MIL-D-22531A(WEP)
AMENDMENT 2
1 JUNE 1964

MILITARY SPECIFICATION

DISPLAY-PLOTTING BOARD GROUP OA-1768(*)/ASA-13

This amendment forms a part of Military Specification MIL-D-22531A(Wep) dated 10 August 1961 and has been approved by the Bureau of Naval Weapons, Department of the Navy

FIGURE 1B

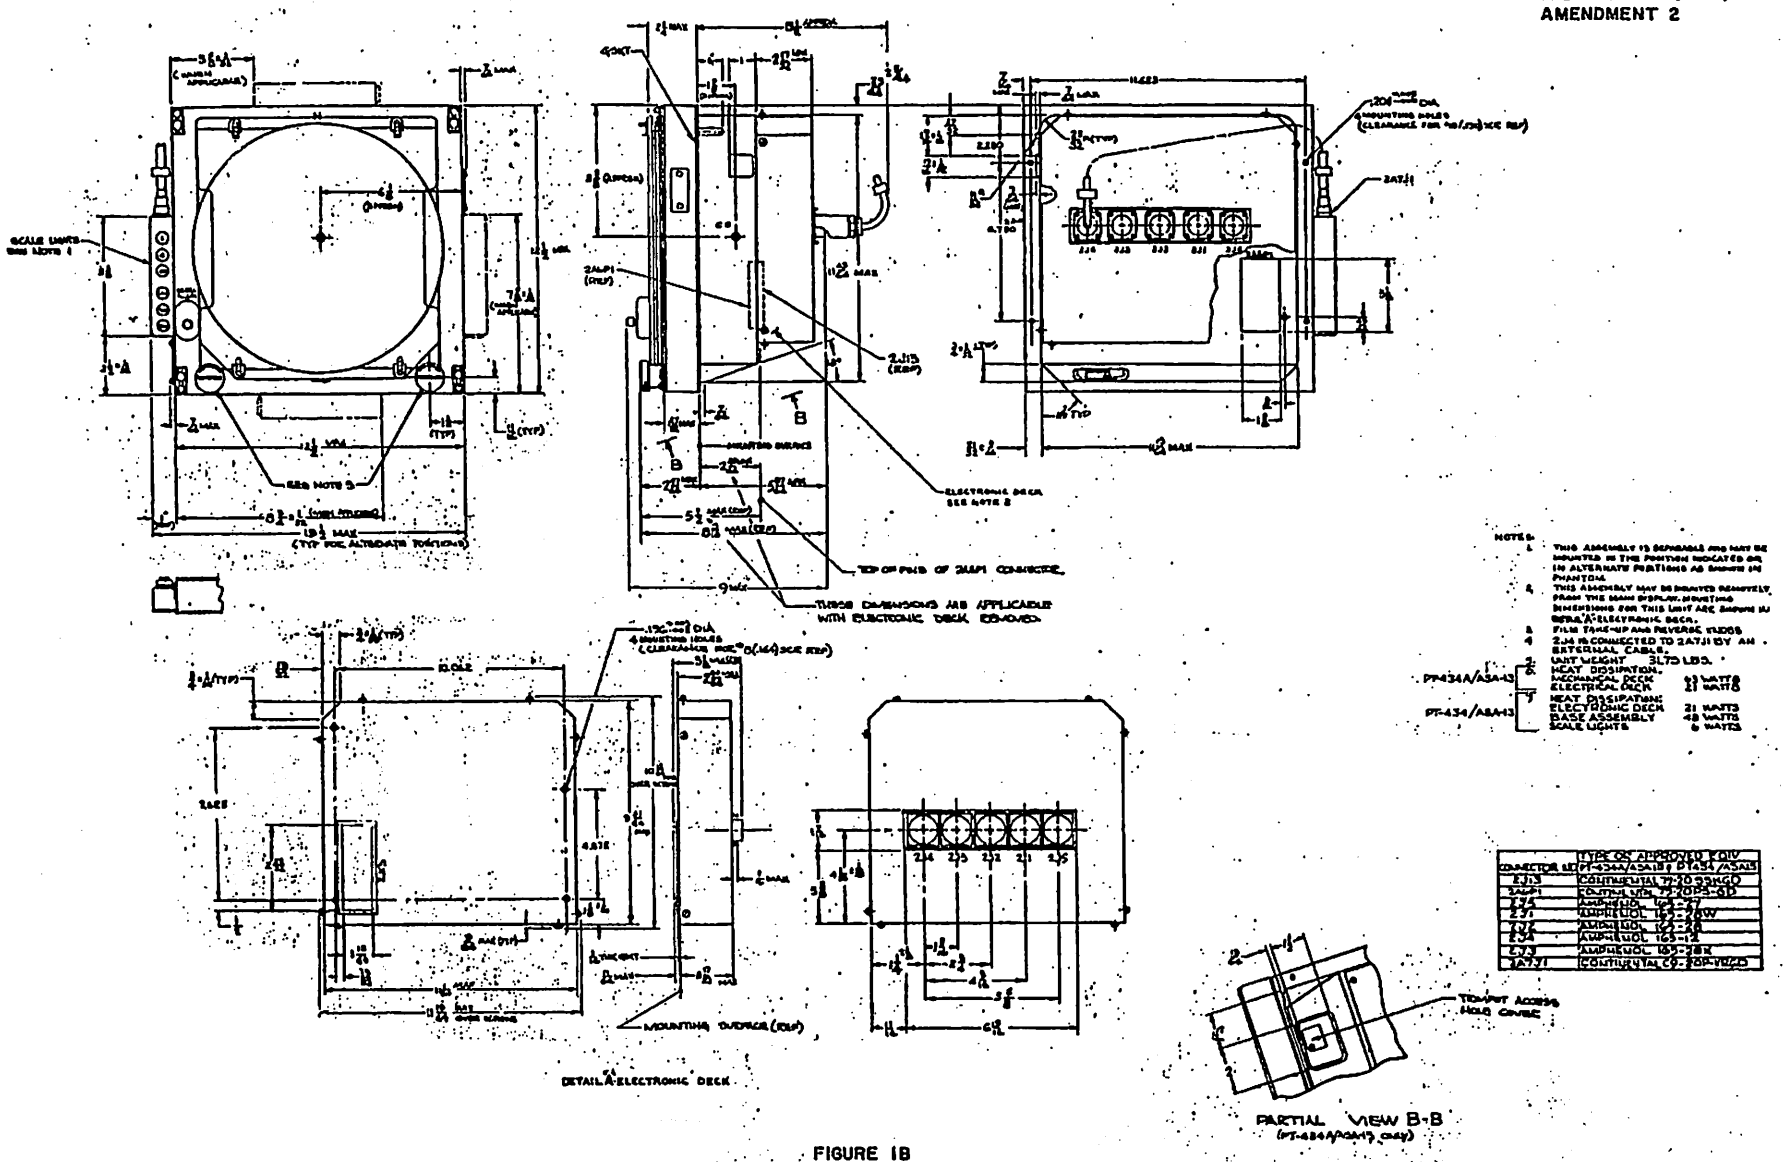
Page 20: Delete figure 1 and substitute new figure 1B.
